## Planning Application: 6/2022/2801/MAJ - Objection

### Objection Reasons

Figure 3- potentially random circle with no reference or link to text or vice versa

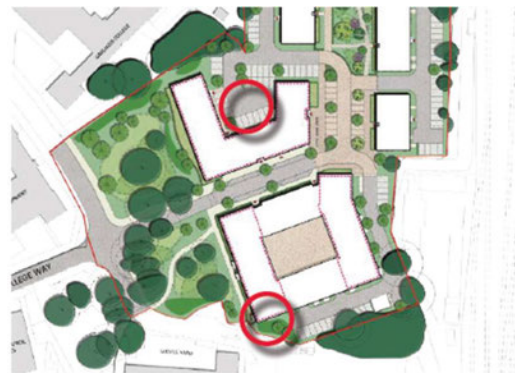
Figure 3 is confusing and there isn't an obvious link between the circles and the text. For example there is a circle over the (new) car park but no mention in the text

There is extensive mentions of Blocks A , B etc – but these aren't annotated on the plans. It assumes the reader knows somehow from a different document or more likely prior conversation. This is poor quality, isn't written for consultation or approval . Poor quality now also suggests poor quality will flow through the whole development
